MILITARY SPECIFICATION

GAGES, PLUG AND RING, THREAD

This amendment forms a part of Military Specification MIL-G-45654, dated 30 December 1959, and is approved for use by all Departments and Agencies of the Department of Defense.

FIGURE 1. Removal of partial thread and chip groove.

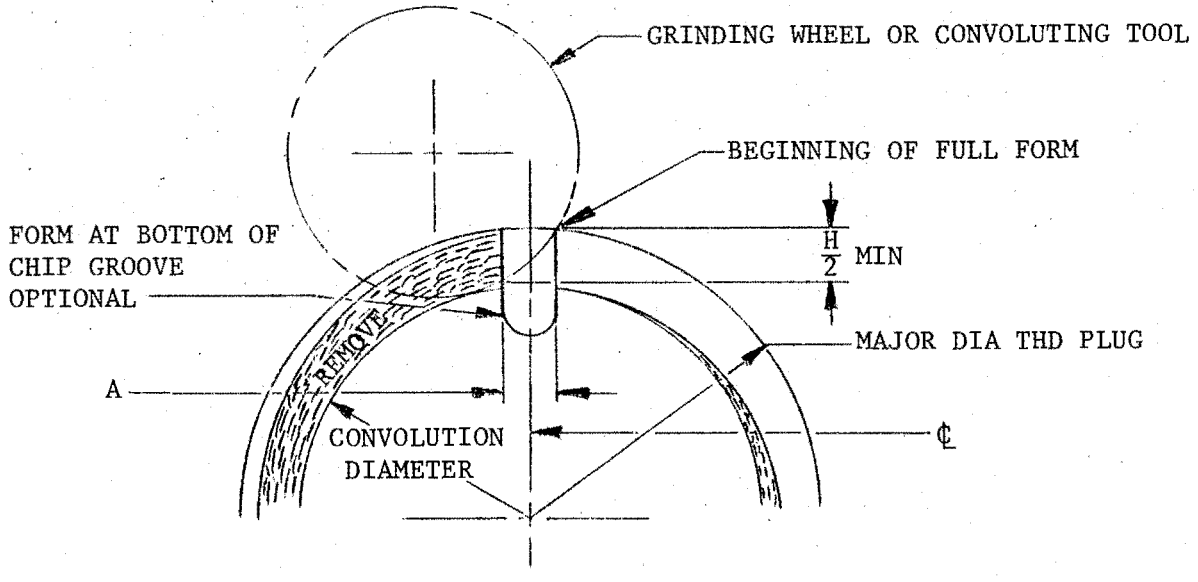
3.1.2.2: Delete in its entirety and substitute:

3.1.2.2 Chip Groove. Go thread plug gaging members, except in nominal thread sizes up to and including No. 8 (0.164), shall be provided with a chip groove(s). Chip grooves are acceptable that are in accordance with general commercial practice, such as a groove cut at an angle with the axis or a longitudinal groove cut parallel with the axis and extending the complete length of the gaging member. The groove shall be located circumferentially at the start of the full thread, and in all cases the depth shall extend below the root of the first full thread space. One chip groove is required at the front end of the gaging member, unless the gaging member is reversible which requires one chip groove at each end. The preferred widths for chip grooves are as follows:

3.1.2.3, On page 4, line 7: Add after "...the root of the thread." "The convolution rise due to the radius of the convoluting tool shall be no greater than H/2 measured from the major diameter of the Go thread plug gage as shown in Figure 1. The beginning of the first full thread shall be sharp and of full form and contain no indentations or nicks.
